# UNITED STATES PATENT AND TRADEMARK OFFICE

APPLICATION NO.	FILING DATE	FIRST NAMED INVENTOR	ATTORNEY DOCKET NO.	CONFIRMATION NO.
10/754,394	01/09/2004	Michael Frank Walsh	WMFR-P01-001	9186
28120	7590	09/09/2004	EXAMINER	
ROPES & GRAY LLP ONE INTERNATIONAL PLACE BOSTON, MA 02110-2624			GARCIA, ERNESTO	
			ART UNIT	PAPER NUMBER
			3679	
DATE MAILED: 09/09/2004

**Office Action Summary**

### DETAILED ACTION

**FIG.3.**

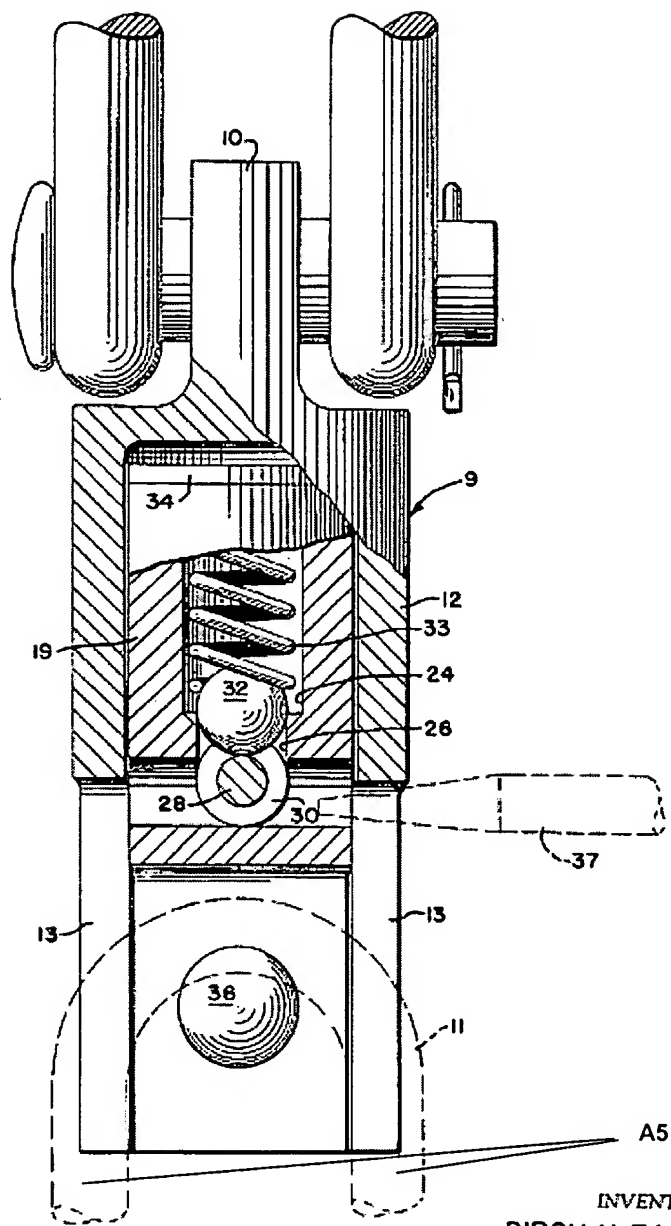
Claims 1, 2, 4-7 and 9 are rejected under 35 U.S.C. 102(b) as being anticipated by Eakin, 3,009,729 (see marked-up attachments).

Regarding claim 1, Eakin discloses, in Figures 1-4, a low-force release mechanism comprising a main structure **9**, a trap **19**, an internal spring activation element **33**, at least one trigger **37**, attachments **A5** and a container **7**. The spring activation element **33** interacts with an internal geometry **24** of the trap **19**. The container **7** is attached to the main structure **9** and the trap **19**. Applicant is reminded that the examiner has considered the mechanism in combination with the container as

Regarding claim 2, the mechanism further comprises at least one ball bearing **32**.

Regarding claim 4, the mechanism further comprises low frictional ball bearings **32**.

Regarding claim 5, the mechanism further comprising a hangar **10**.

Regarding claim 6, the mechanism further comprising a hangar **11**.

Regarding claim 7, the spring activation element **33** employs a spring device.

Regarding claim 9, Eakin discloses, in Figures 1-4, a low-force release mechanism comprising a main structure **9**, a trap **19**, an internal spring activation element **33**, at least one trigger **37**, attachments **A5** and a container **7**. The spring activation element **33** interacts with an internal geometry **24** of the trap **19**. The container **7** is attached to the main structure **9** and the trap **19**. Applicant is reminded that the examiner has considered the mechanism in combination with the container as the limitation "by which" is two-fold and the examiner concluded that applicant is claiming the container as evident by claim 8 further limiting the container.
